BEFORE THE NORTH CAROLINA UTILITIES COMMISSION

In the Matter of)
)
Duke Energy Progress, LLC, and) DOCKET NO. E-100, SUB 179
Duke Energy Carolinas, LLC, 2022)
Biennial Integrated Resource Plan)
and Carbon Plan)
_____)

DIRECT TESTIMONY AND EXHIBITS OF

TYLER FITCH

Figure 2. Manual Changes to Duke Energy Carbon Plan Portfolio 1 through 2035 and 2050

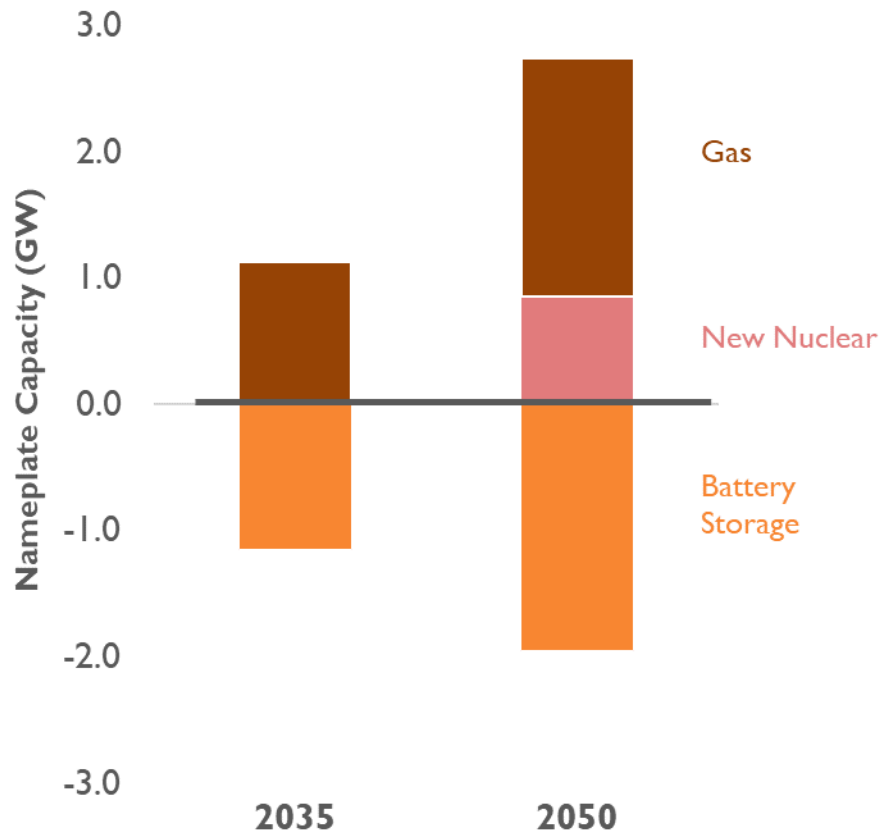
1 Through 2035, Duke Energy's overrides to EnCompass cause an
2 additional 1 gigawatt ("GW") of gas combustion turbines to be added to the
3 system, at the expense of 1 GW of battery storage technologies. By 2050,
4 these manual changes result in the addition of nearly 3 GW of gas and
5 nuclear capacity, and the removal of 2 GW of battery storage capacity.
6 These new gas plants would then need to be converted to burn 100 percent
7 zero-carbon hydrogen, when it is not yet known whether that conversion is
8 feasible, or what the cost will be. Any new nuclear plants would rely on
9 technologies that are not commercially available today. For context, 2022
10 generation capacity across DEC and DEP is roughly 40 GW; these manual
11 revisions represent an eighth of 2022 generating capacity.

1 A. I recommend that the Commission reject the manual changes made by
2 Duke to its portfolios because they deviate from least-cost resource
3 planning and lack an economic or resource adequacy justification. If the
4 Companies believe that additional reliability or resource adequacy analyses
5 are necessary, they should implement these in advance of capacity
6 expansion modeling (via resource adequacy studies and/or effective load
7 carrying capability studies) and allow optimization software to choose the
8 most economic resource pathway that meets reliability requirements. At
9 present, the manual revisions add dependence on gas and nuclear
10 resources with no clear benefit to ratepayers.

Figure 5. Duke Energy Carolinas Annual Incremental Savings Target

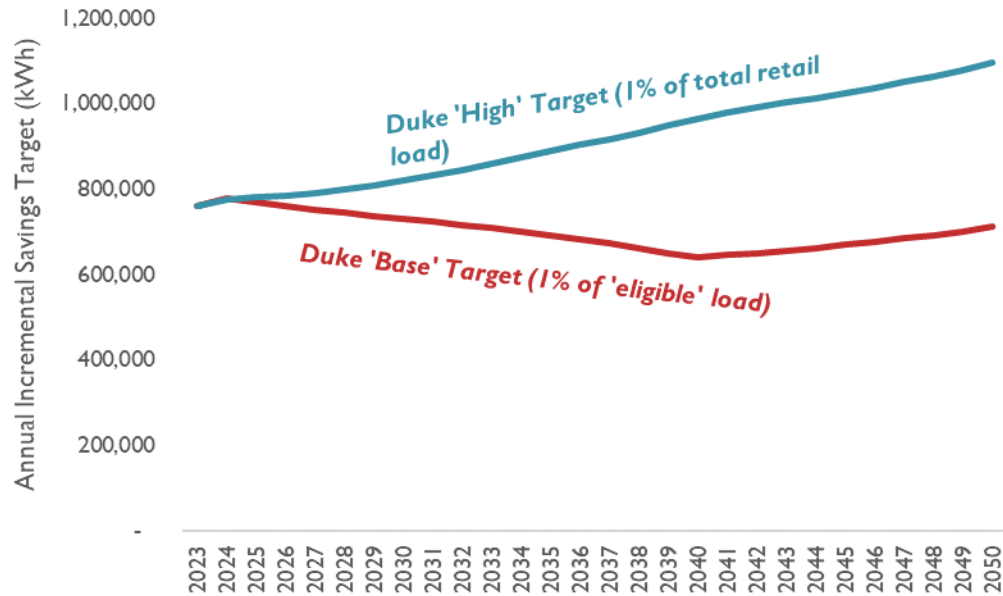
- 23 A. Duke Energy modeled energy efficiency as a decrement to load based on
24 two different forecasts of annual incremental savings. Specifically, the
25 Company’s “Base” energy efficiency forecast assumes incremental annual
26 energy savings of one percent of Duke’s retail load, net of load that has
27 opted out of energy efficiency programs. The “High” forecast assumes
28 savings equivalent to 1 percent of total retail load.⁶⁶ Figure 2, below, shows
29 annual incremental savings targets for the “Base” and “High” forecasts
30 used in developing Duke’s portfolios.

1 position is supported by other intervenors, including the Attorney General⁷⁹
2 and Tech Customers.⁸⁰ Therefore, I recommend that the Commission
3 integrate higher energy efficiency and behind-the-meter solar forecasts in
4 its Carbon Plan, and direct the Companies to develop programs that are
5 able to accommodate these increased forecasts.
